## Ninilchik River Estates Wilson 2023 Addition Preliminary Plat

#### ITEM #2 - PRELIMINARY PLAT NINILCHIK RIVER ESTATES WILSON 2023 ADDITON

KPB File No.	2023-124R1		
Plat Committee Meeting:	April 22, 2024		
Applicant / Owner:	Diane Wilson Family Trust of Ninilchik		
Surveyor:	Jerry Johnson/ Johnson Surveying		
General Location:	Ninilchik Oil Well Road

#### STAFF REPORT

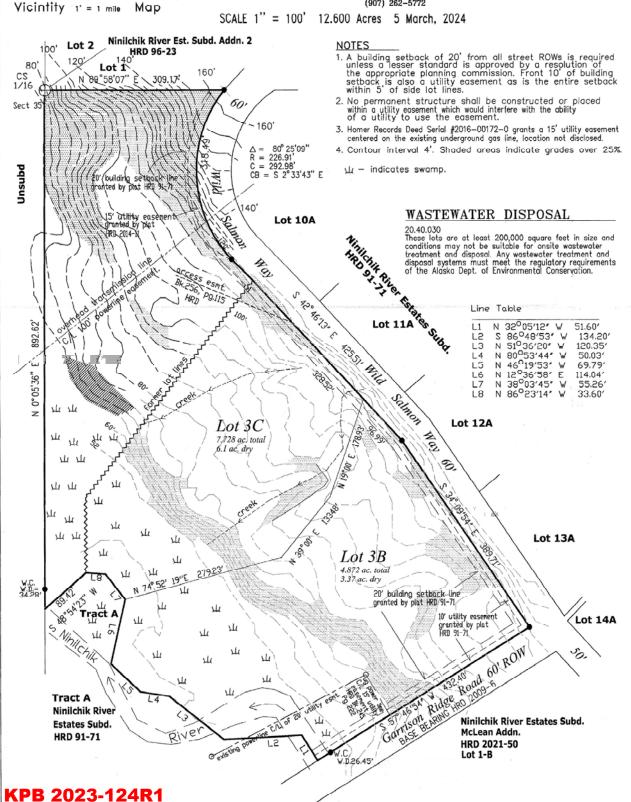
The certificate to plat has supplied a document at book 245 page 608 indicating an easement for right of ingress and egress. This easement needs to be added to the drawing and added as a plat note.

There are areas on the plat that are over 20 percent grade shown as shaded on the drawing. The parent plat labels these spots as top and toe which the surveyor can convert to showing and remove the contours on the submittal of the final.

FEMA FIRM Zones A and X. The KPB Floodplain Administrator has noted that the surveyor will need to add a BFE (Base Flood Elevation) to the plat be 20.30.280. the surveyor has requested an exception to 20.30.280(A) & (C). Per 20.30.280(D) the surveyor will need to add the Flood Hazard Notice note tot eh plat.

The rear 10 feet of the front 20 feet of Lot 6-A of HM 91-71 is granted as an electrical easement per 249 / 113 from the certificate to plat, please add this to the drawing and as a plat note.

Add the easements listed in Book 248 / 890 to the drawing and as a plat note.

Add the HEA right-of-way easement listed in book 48 page 74 to the drawing and as a plat note.

Add the blanket easement to HEA listed in book 27 page 8 to the plat notes.

Area of plat does not equal area from total of the parent plats added together.

Add KPB No 2023-124R1

Add a note that "The borough will not enforce private covenants, easements or deed restrictions per KPB 20.60.170."

Transfer all notes from the parent plats forward to this plat.

Update subdivision area to include additional area added.

Show some roads adjacent to the site

Add the townships and range to the map

Lots east and south need dashes added to the lot numbers

## Floodplain Determination

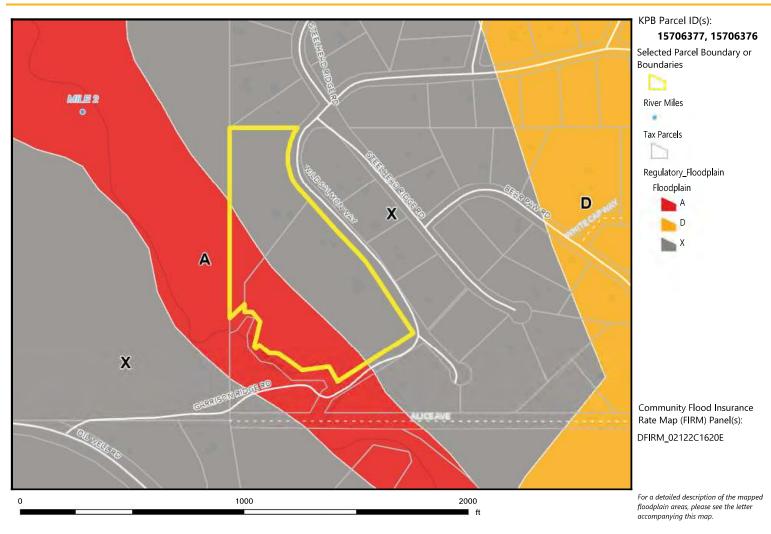
Per our FIRM for that area, the property is subject to an unnumbered A Zone with no Base Flood Elevation (BFE) configured. Per 21.06.050(A)(6), "Where base flood elevation data has not been provided or is not available from another authoritative source, it shall be generated for subdivision proposals which contain 50 lots or 5 acres, whichever is less. The floodplain requirements for subdivision plats, detailed in KPB 20.30.280, apply to all subdivision proposals." Due to the acreage involved with this plat, configuring the BFE will be required. As the Floodplain Administrator my responsibility it to protect lives and property from flood events and during my review determined that two options are available.

- 1. The unnumbered A Zone is only on a small portion of the proposed subdivision.
  - 2. The unnumbered A Zone boundary correlates with steep terrain. (I found 80% in what appeared to be steepest area.)

If you do select the second option, the boundary of Zone A will be required to be clearly shown and labeled. In addition to the normally required floodplain plat notes, you will need to include "Prior to any development within the mapped floodplain Zone A, the base flood elevation must be generated and submitted with the floodplain permit application."

- 1. Figure the BFE for the subdivision. Clearly mark on the plat the BFE(s) and include a plat note stating when and the methods used to determine them; or

- 2. Based on my following findings, which I feel show that there is a minimal risk to life and property involved with this subdivision plan, you are not required to figure the BFE but a specific plat note will be required.
